Great Yarmouth Third River Crossing Order 202[*]

Document NCC/GY3RC/EX/064: Response to Written Submissions made by the Environment Agency at Deadline 5

Author: Norfolk County Council

Date: 11 February 2020

FIGURE 1 BASELINE PRESENT DAY - 5% AEP MODELLLED FLOOD EXTENTS (REGULATION 5(2)(a))

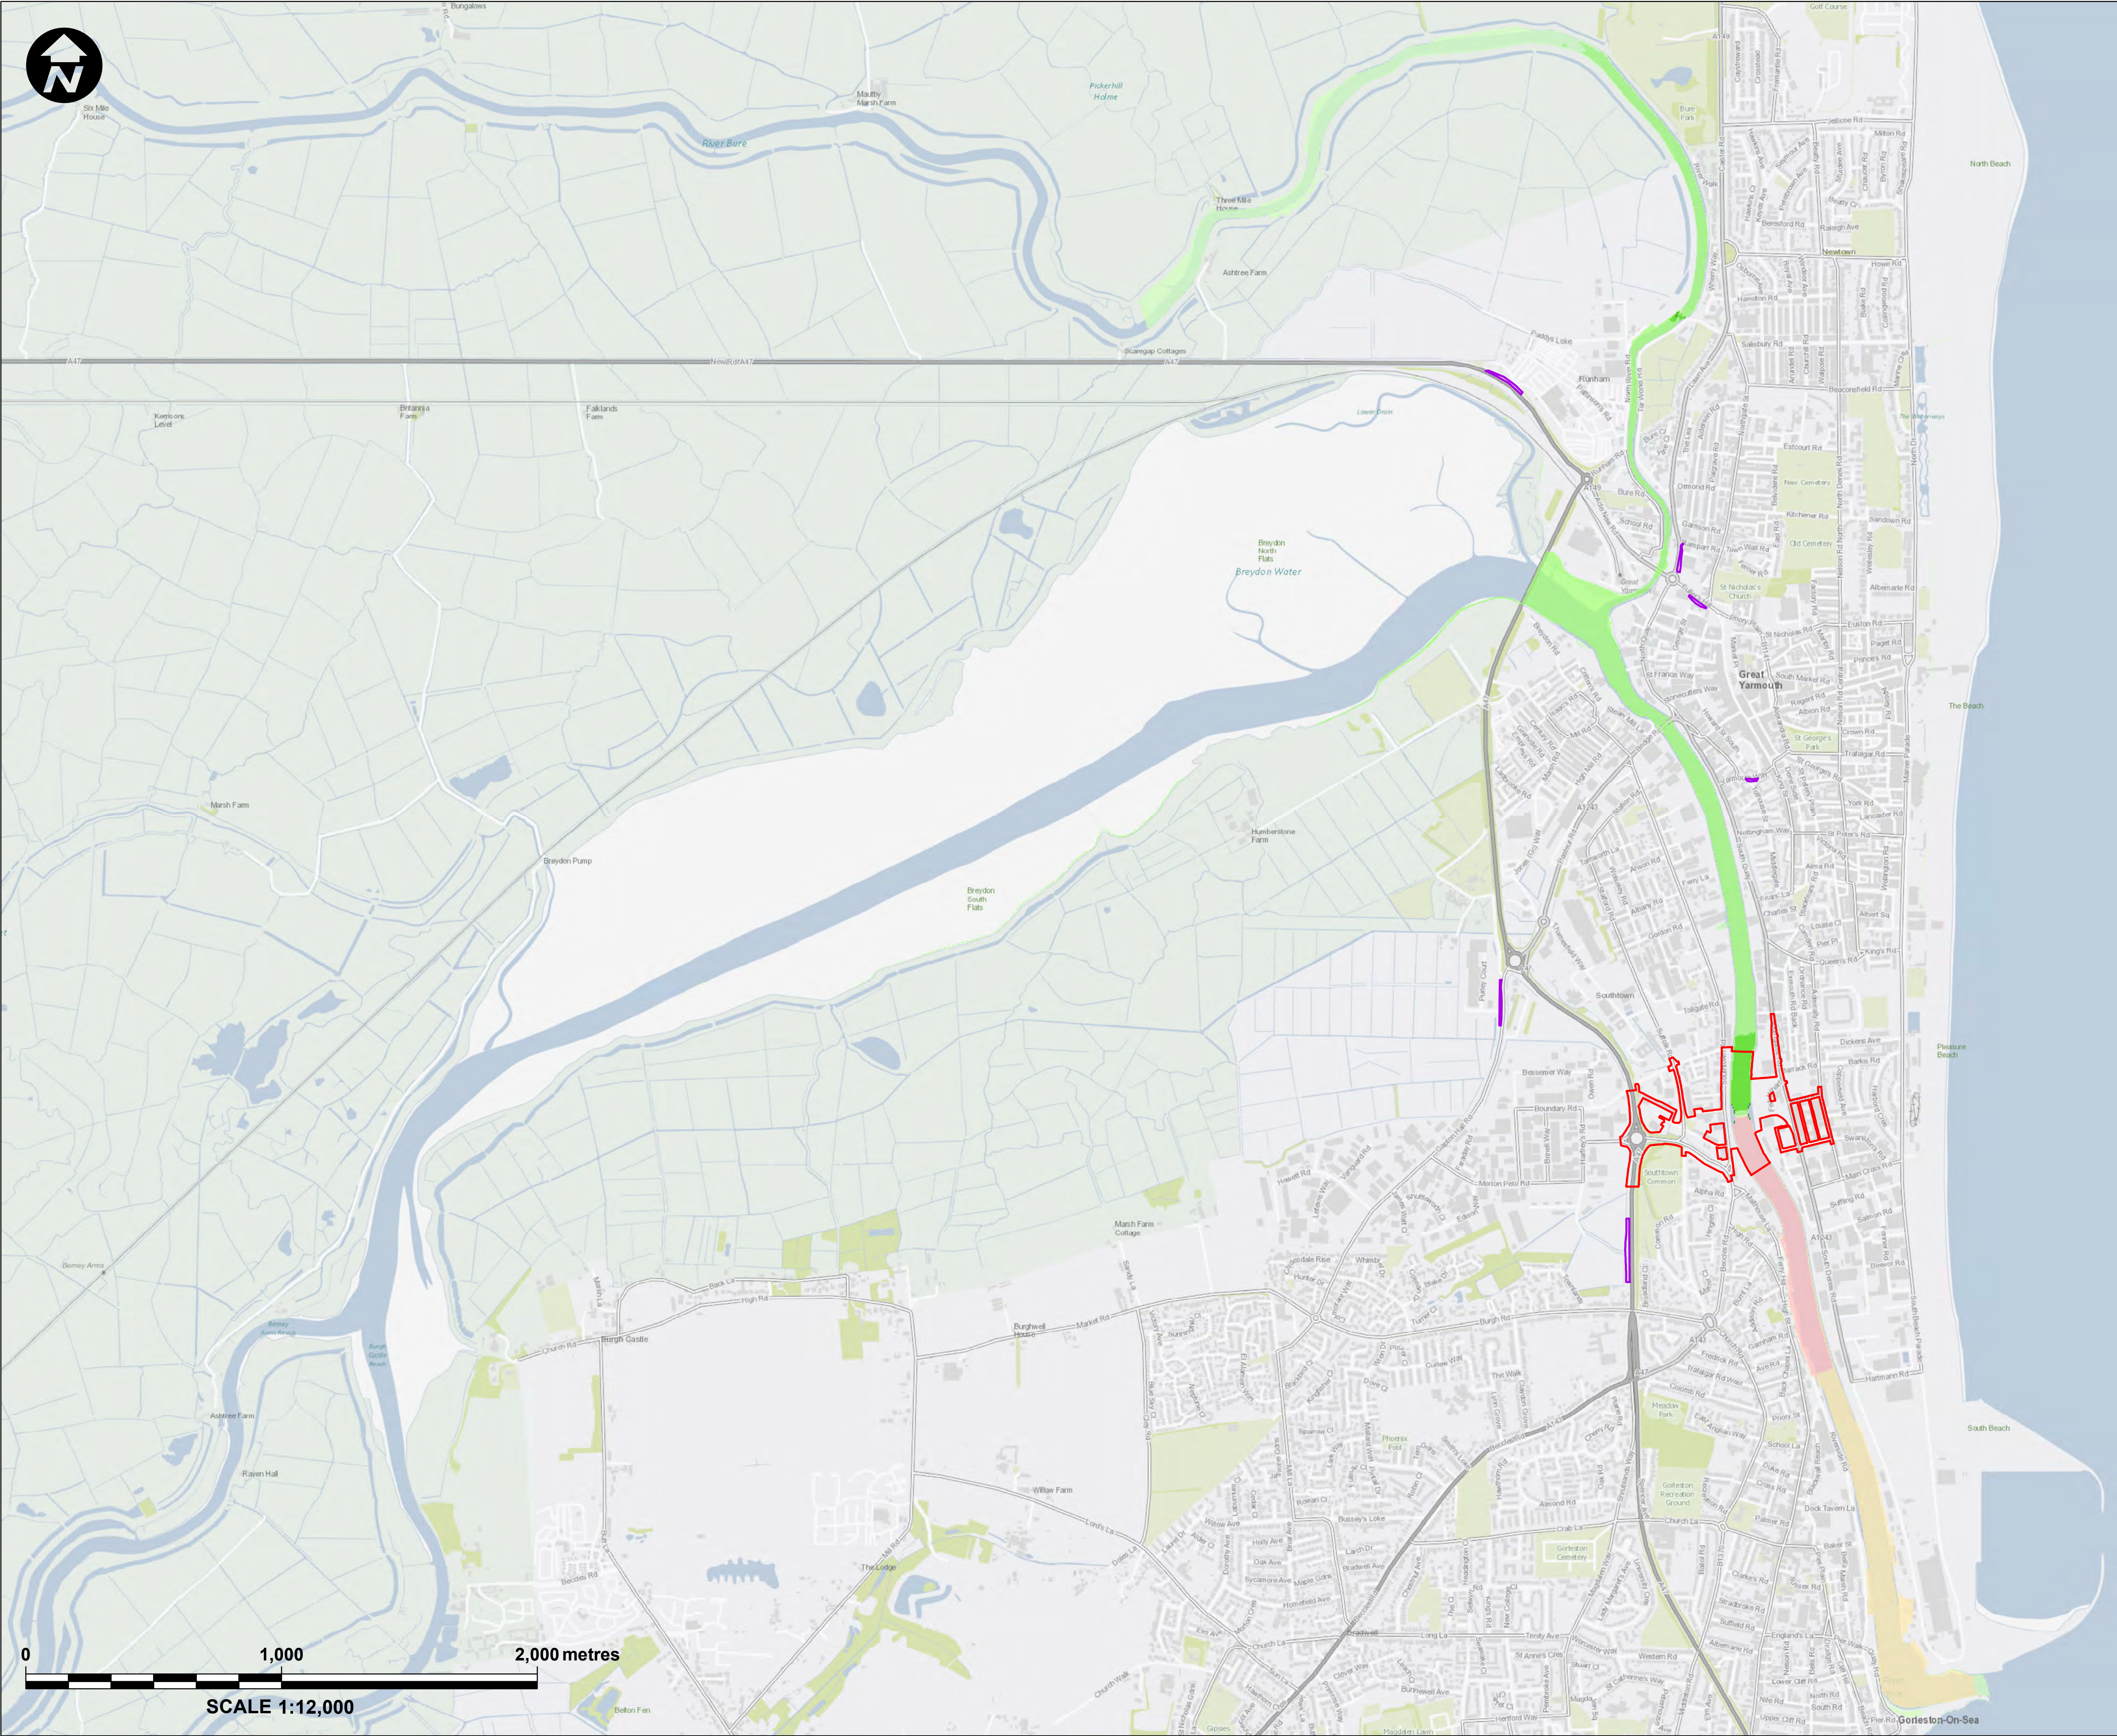
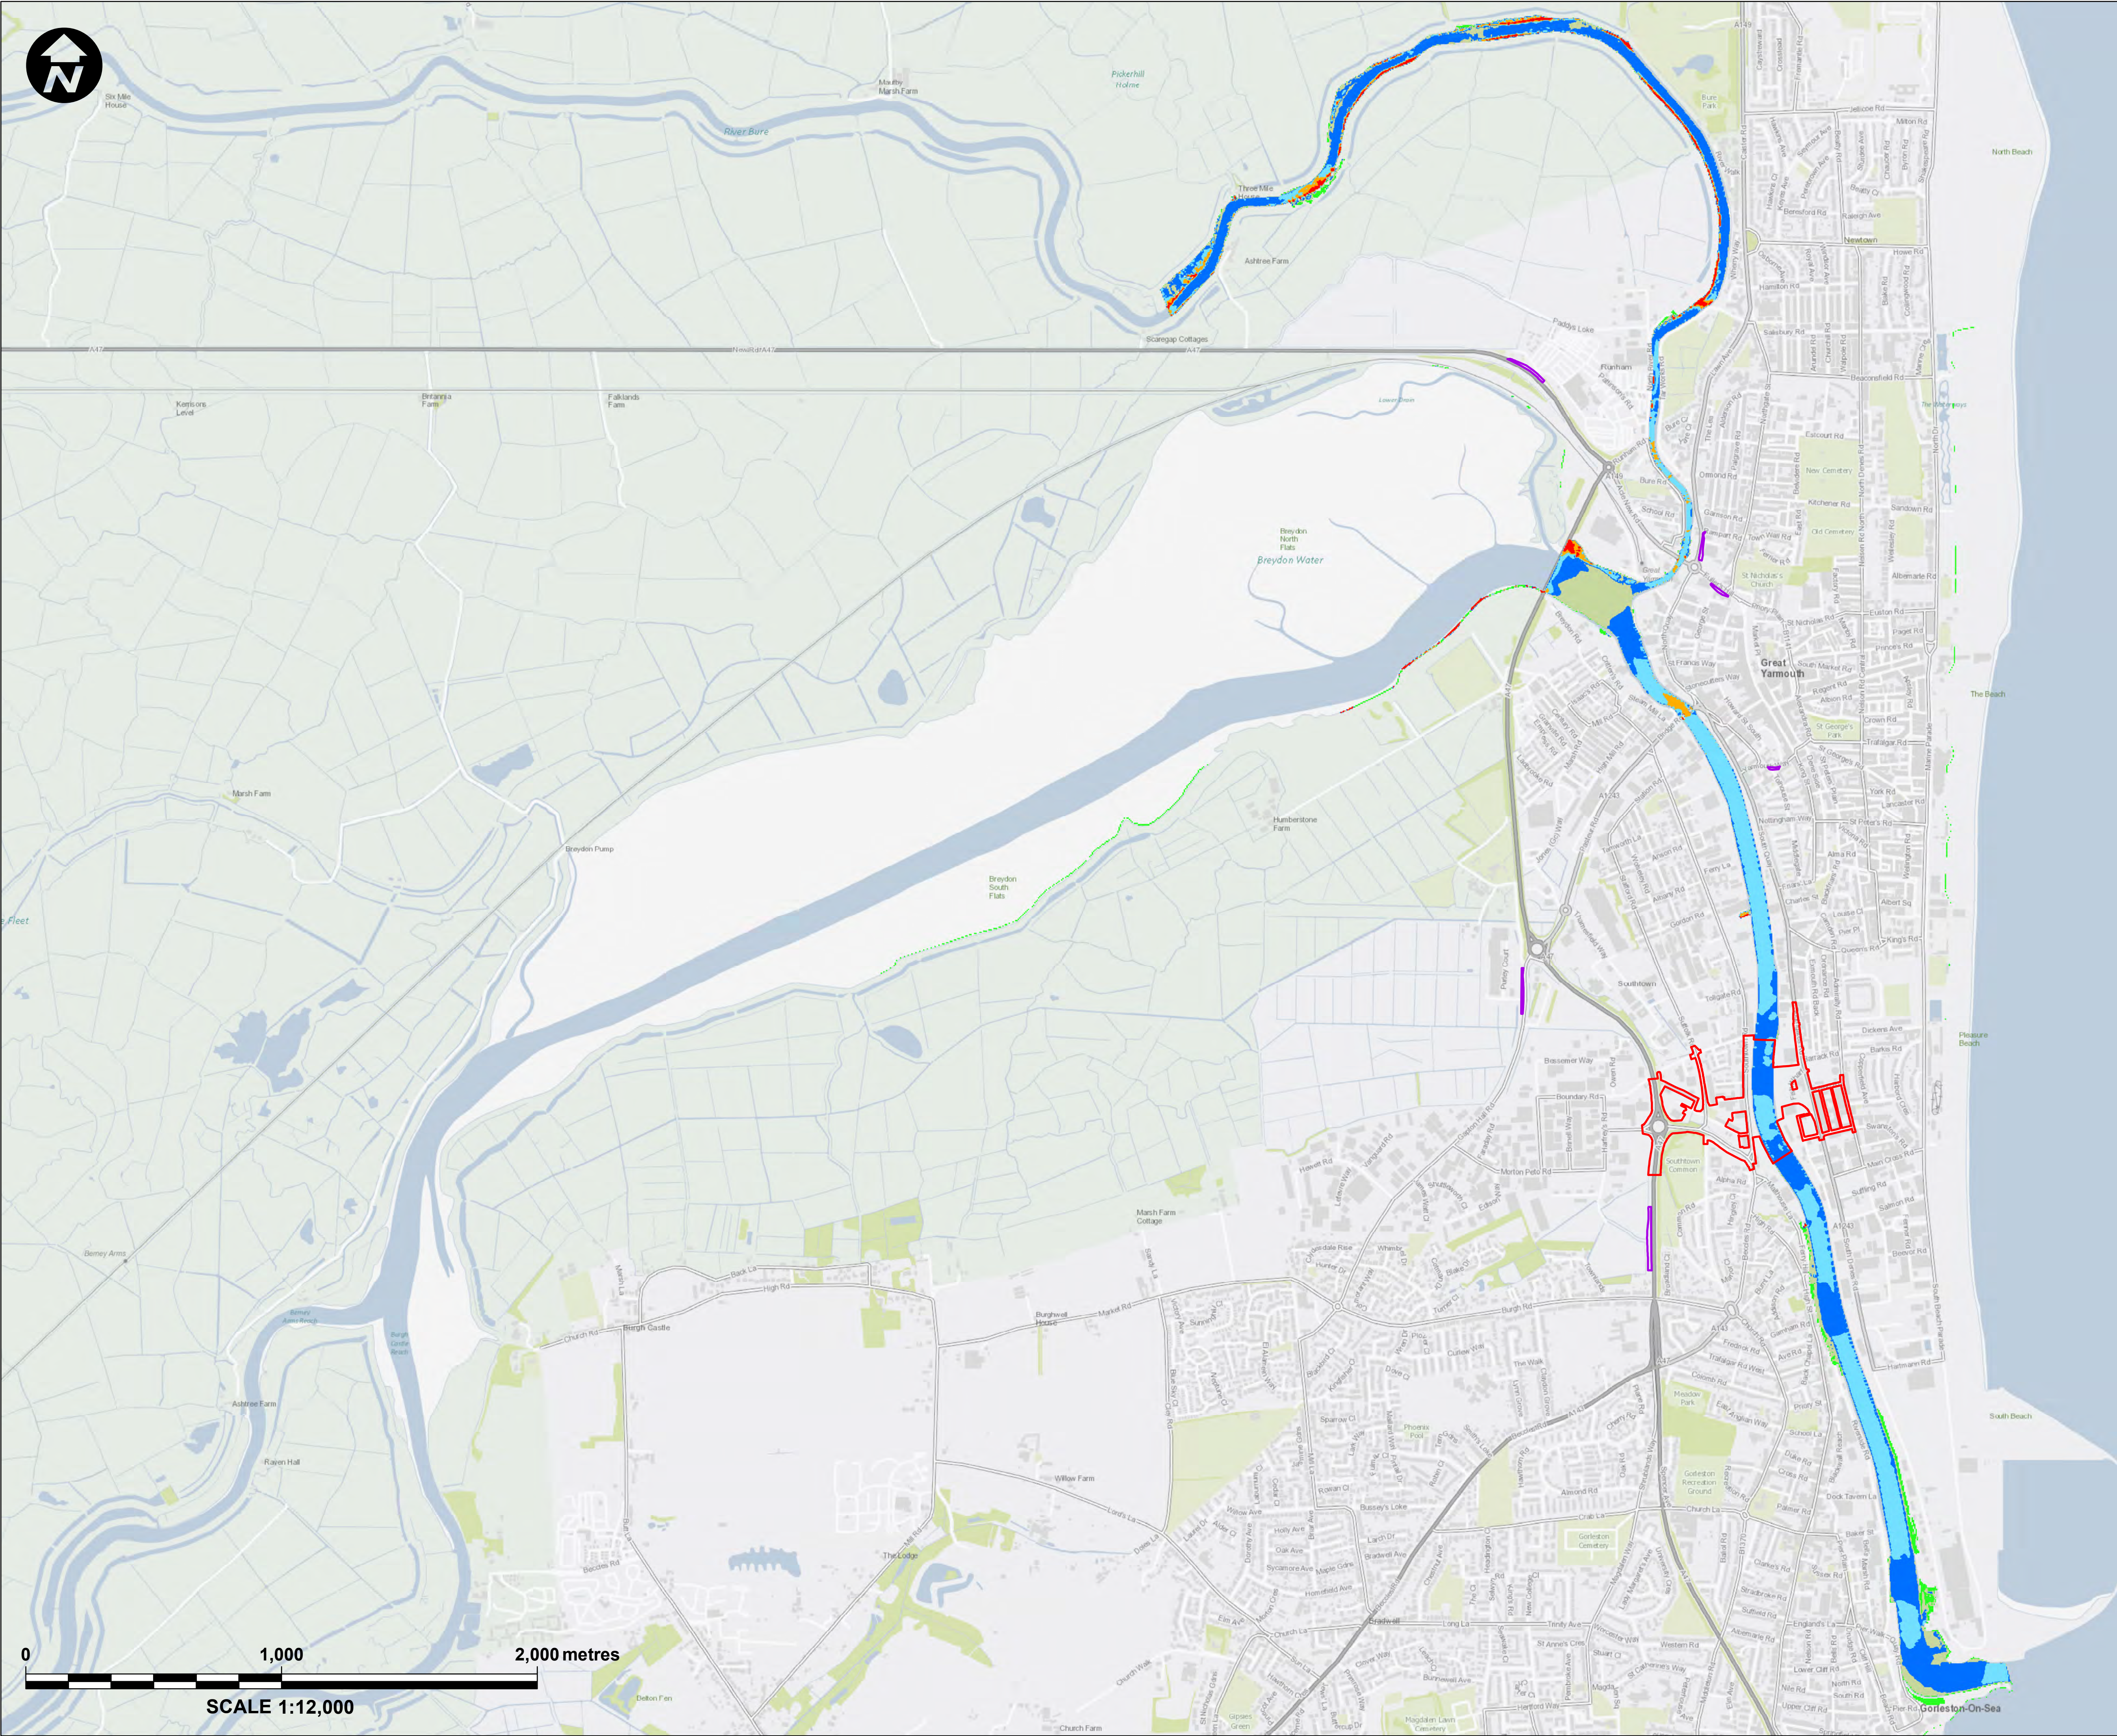
- 2.1.51 Section 6.2.45 of the FRA states that these in-channel changes for the 5% (1 in 20) AEP plus climate change event have less impact on the floodplain than the changes in the current day event. However, figure 12.8 shows that the baseline 5% (1 in 20) + AEP plus climate change event is flooding the floodplain, when the current day 5% (1 in 20) AEP event shows that the floodwater remains in channel. No figure has been provided showing the change in flood level or hazard on the floodplain for the 5% (1 in 20) AEP plus climate change event, so any change in risk in the floodplain is unknown.

2.1.56 The Applicant notes that the Environment Agency's interpretation of section 6.2.45 is not correct as the statement applies to all events not just the 5% AEP plus climate change. Figure 12.8 (Document Reference 6.3, Planning Inspectorate Reference APP-169) does confirm that the floodplain is inundated when climate change is added to all events. The depth and hazard maps are provided for the 0.5% and 0.5% plus climate change events with Document Reference 6.3, Planning Inspectorate Reference APP-169.

2.1.57 A set of figures showing the impact on flood risk for the 5% AEP event have been extracted from the hydraulic model and are presented in Appendix C. This set of figures has been requested by the Environment Agency. These figures show that the 5% AEP flows remain within the flood defences and that the scheme does not impact on the water levels. Therefore, they do not change the conclusions of the FRA (Document Reference 6.2, Planning Inspectorate Reference APP-135) and are provided for clarification purposes only.
